# Clause 104 Maintenance Requests #3

# Overview

Technical, 802.3cg, Page 93, Table 104-7, Item 6b

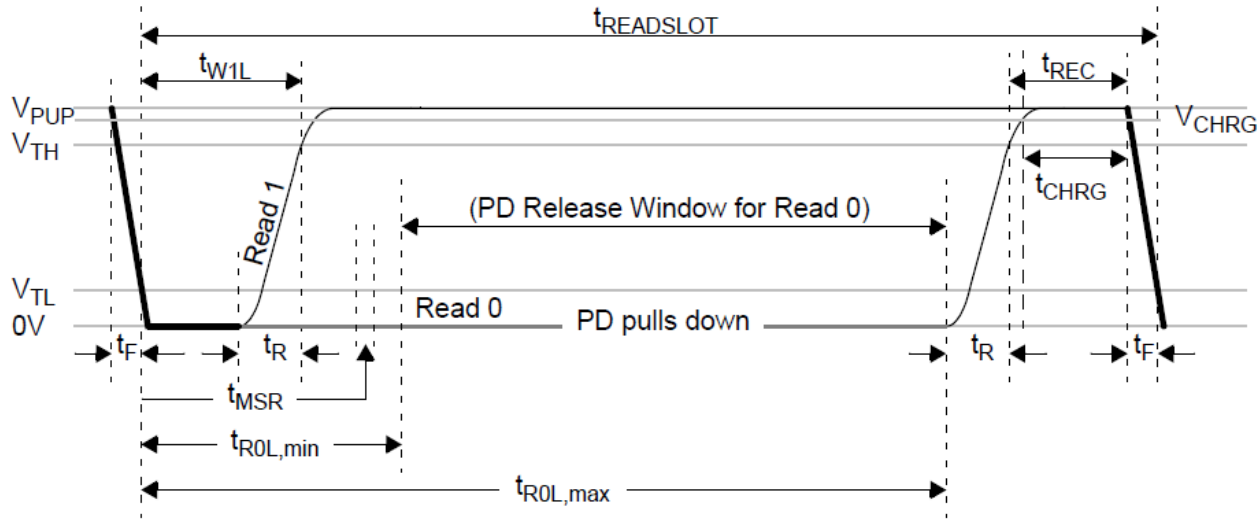
## Comment

- ▶ C<sub>IN\_CLASS</sub> is limited to ensure that excessive rise and fall times do not interfere with SCCP
  - Other timing parameters are affected by C<sub>IN\_CLASS</sub>
  - t<sub>R</sub> and t<sub>F</sub> were generous and can already accommodate C<sub>IN\_CLASS</sub> of up to 0.8uF
- ▶ C<sub>IN\_CLASS</sub>, max is 0.4uF for Type E
- ▶ This value is unnecessarily restrictive and potentially infeasible
  - A reservoir cap is required to maintain PD operation during Reset commands

Modify Table 104-7, Item 6b

6b	Input capacitance during DO_CLASSIFICATION state	C <sub>IN_Class</sub>	μF	—	0.2	<del>A, A<sub>1</sub></del> <u>B, C, D</u>	All classes <u>Applies during t<sub>R</sub> and t<sub>F</sub> only.</u>
				=	<del>0.4</del> <u>0.8</u>	<u>E</u>

# SCCP Reset Command Timing

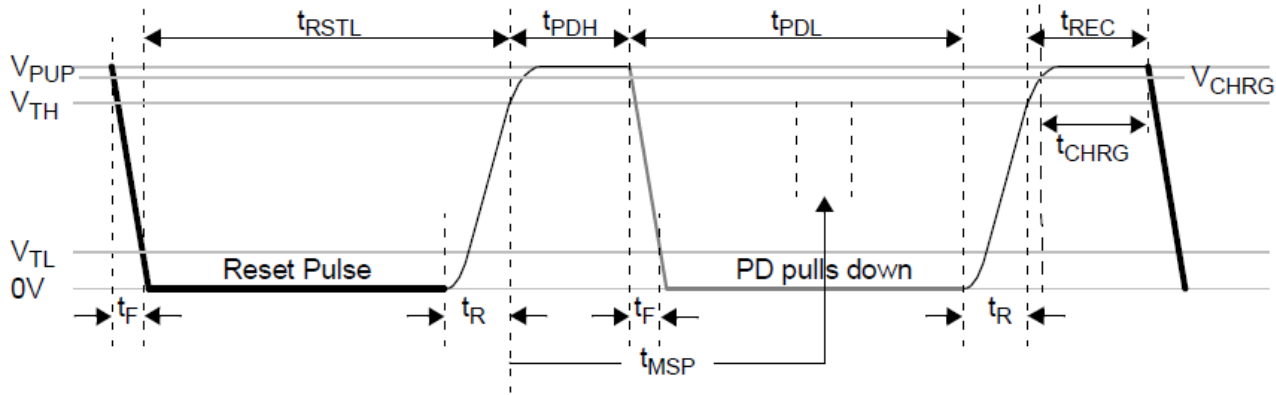
- ▶  $C_{IN\_CLASS}$  change lengthens real-world Reset component timings
- ▶  $T_{PDL}$  was by far the tightest PD timing accuracy requirement
  - Make rationale and economically feasible by increasing to  $\sim\pm 20\%$
- ▶ Incorporate  $t_{REC}$  change as proposed previously
- ▶ **Propose:** Changes as shown

Parameter	Min	Max
$t_F$	0.025	0.25
$t_{RSTL}$	8	10.5
$t_{PDH}$	0.7	1.3
$t_{MSP}$	1.8	<del>2.2</del> <u>2.4</u>
$t_{PDL, E}$	2.8	5.2
$t_{PDL, E w/ CRM}$	21	<del>34</del> <u>39</u>
$t_R$	0.025	0.5
$t_{REC}$	<del>0.27</del> <u>0.5</u>	<del>0.33</del>

# SCCP $t_{\text{READSLOT}}$ Timing

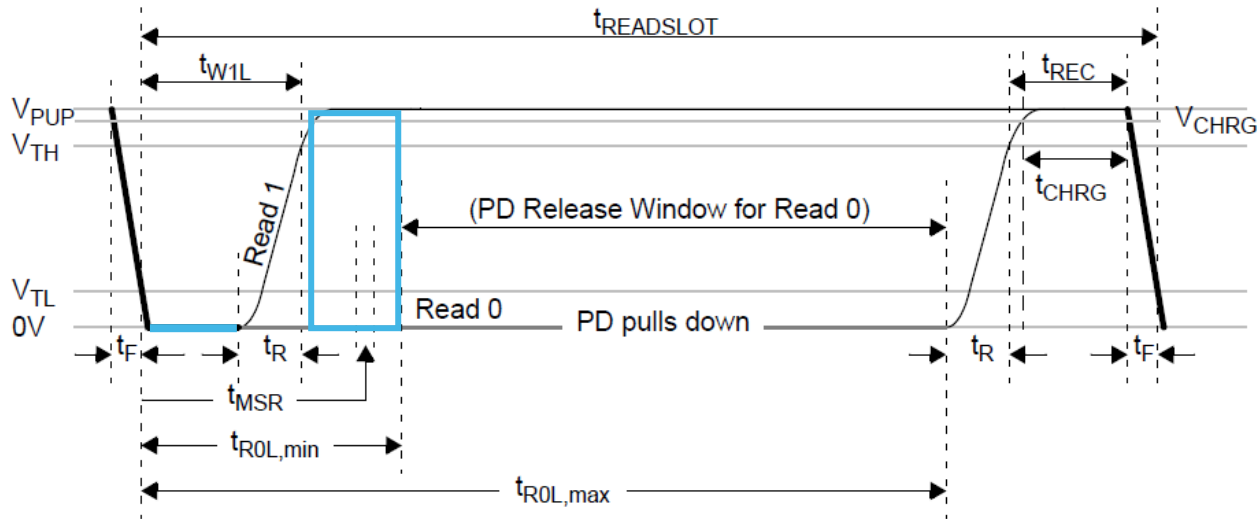
- ▶ Late changes to Read Slot component timing affected  $t_{\text{READSLOT}}$  but were not accounted correctly
  - Original  $t_{\text{READSLOT,max}}$  did not correlate to sum of components
- ▶ Original calcs did not account for PSE and PD discrepancies for  $t_{\text{R}}$  and  $t_{\text{F}}$  in end-to-end systems
- ▶ Incorporate  $t_{\text{REC}}$  change as proposed previously
- ▶ **Propose:** Changes as shown

Parameter	Min	Max
$t_{\text{F}}$	0.025	0.25
$t_{\text{MSR}}$	0.9	<del>1.4</del> <u>1.3</u>
$t_{\text{R0L}}$	1.75	3.25
$t_{\text{R}}$	0.025	0.5
$t_{\text{REC}}$	<del>0.27</del> <u>0.5</u>	<del>0.33</del>
$t_{\text{READSLOT}}$		<del>3.83</del> <u>5</u>

# SCCP $t_{\text{WRITESLOT}}$ Timing

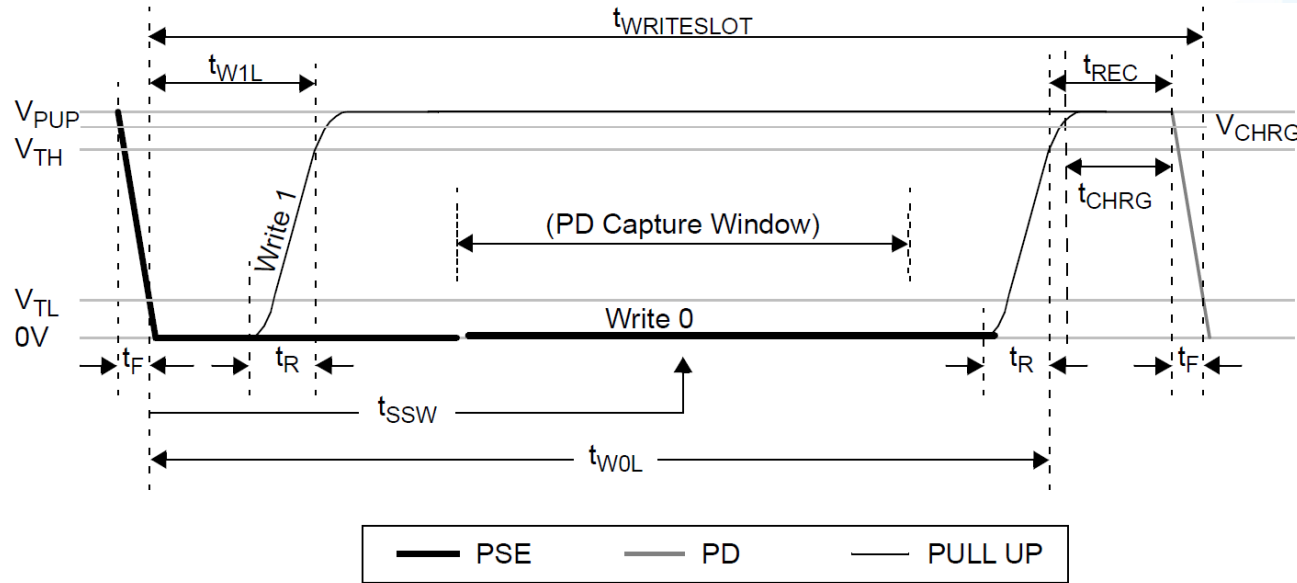
- ▶ Original calcs did not account for PSE and PD discrepancies for  $t_{\text{R}}$  and  $t_{\text{F}}$  in end-to-end systems
- ▶  $C_{\text{IN\_CLASS}}$  change lengthens real-world Write Slot component timings
- ▶ Incorporate  $t_{\text{REC}}$  change as proposed previously
- ▶ **Propose:** Changes as shown

Parameter	Min	Max
$t_{\text{F}}$	0.025	0.25
$t_{\text{W1L}}$	0.09	<del>0.61</del> <u>0.64</u>
$t_{\text{W0L}}$	1.8	<del>2.2</del> <u>2.6</u>
$t_{\text{R}}$	0.025	0.5
$t_{\text{REC}}$	<del>0.27</del> <u>0.5</u>	<del>0.33</del>
$t_{\text{WRITESLOT}}$		<del>2.78</del> <u>3.85</u>

# SCCP $t_F$ Timing

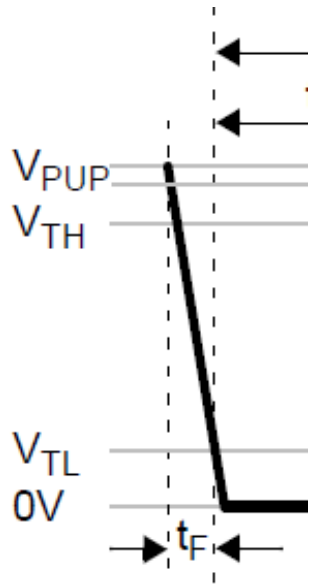
- ▶  $t_{F,min}$  is over-specified and serves as a design recommendation while serving no interoperability value
  - Strong negative effect on economic feasibility
- ▶ **Propose:** Change as shown

Parameter	Min	Max
$t_F$	0.025 <u>0</u>	0.25

Figure 104-10—Reset command timing diagram

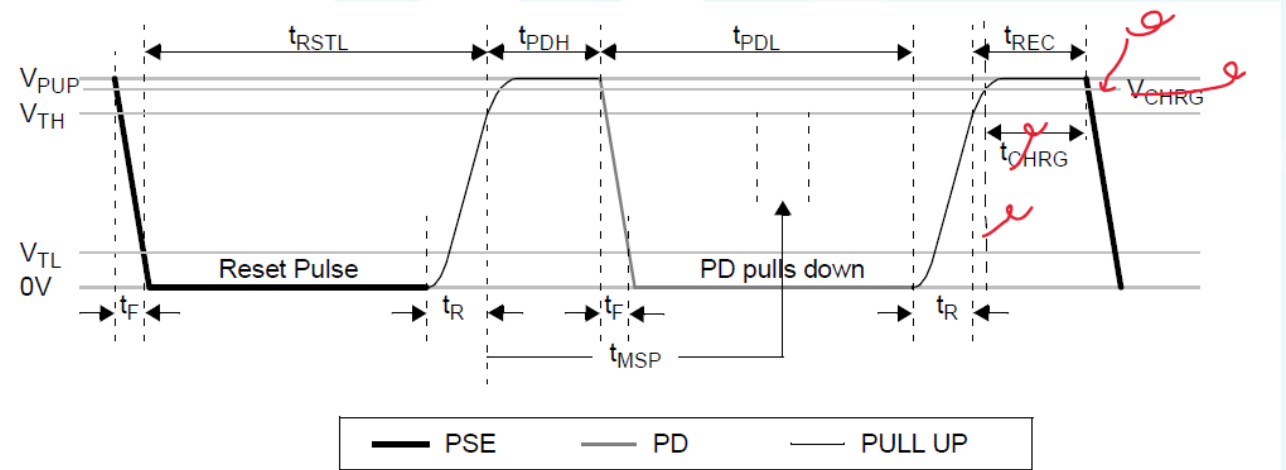
V\_CHRG and t\_CHRG requirements are limiting without bringing value to the standard.

Modify Figure 104-10 as shown.

Remove V\_CHRG and associated voltage line.

Remove t\_CHRG arrow and text.

Remove timing reference dashed line at right end of t\_CHRG arrow.

Figure 104-11—Write 0/1 slot timing diagram

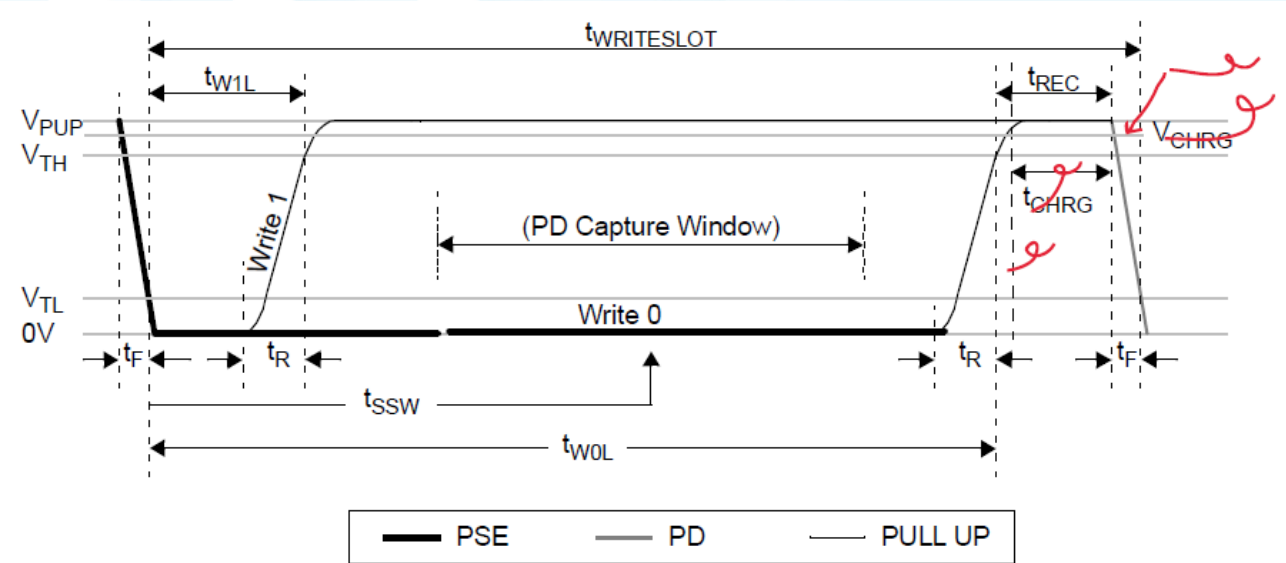
V\_CHRG and t\_CHRG requirements are limiting without bringing value to the standard.

Modify Figure 104-11 as shown.

Remove V\_CHRG and associated voltage line.

Remove t\_CHRG arrow and text.

Remove timing reference dashed line at right end of t\_CHRG arrow.

Figure 104-12—Read 0/1 slot timing diagram

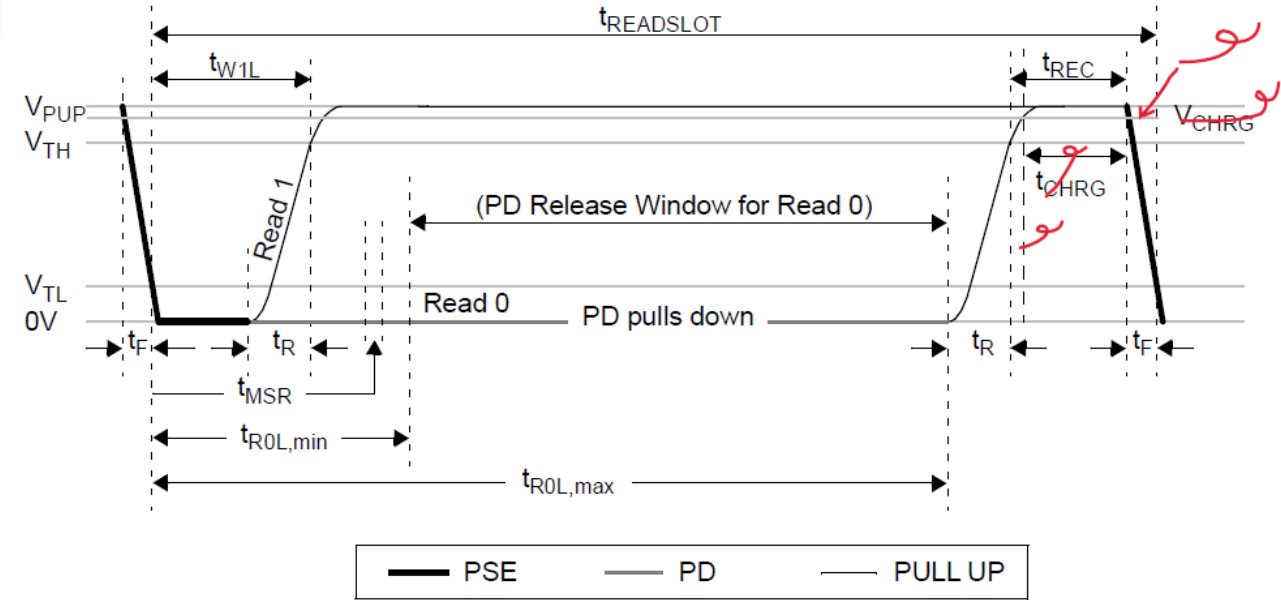
V\_CHRG and t\_CHRG requirements are limiting without bringing value to the standard.

Modify Figure 104-12 as shown.

Remove V\_CHRG and associated voltage line.

Remove t\_CHRG arrow and text.

Remove timing reference dashed line at right end of t\_CHRG arrow.
